Stoneridge Instrument Cluster ABS Malfunction Indicator Noncompliance

RECALL

ABS WIRING UPDATE PROCEDURE

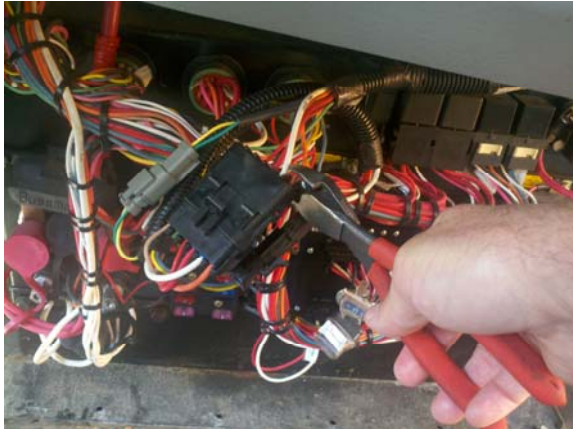
4. Locate connector C504 in PDU (detail shown below). Cut and remove connector C504 from the PDU and ABS harness.

5. Splice each circuit from previous step to the corresponding circuit. Use appropriate terminal as listed below.

“ABS LGT”, “ABS ACTIVE”, circuit use terminal # 00005840.

“ABS GND”, “ABS BATT”, “MOD PUMP BATT”, circuit use terminal # 0036508.

“ABS IGN” circuit use terminal # 00036507.

C504	
ABS IGN (OR)	>A>	ABS IGN (OR)
ABS GND (WH)	>B>	ABS GND (WH)
ABS BAT (RD)	>C>	ABS BAT (RD)
MOD PMP BAT (RD)	>D>	MOD PMP BAT (RD)
ABS LGT (GN)	>E>	ABS LGT (TN)
ABS ACTIVE + (GN)	>F>	ABS ACTIVE + (TN)

Remove two “C504” connectors and splice each circuit to the corresponding circuit.
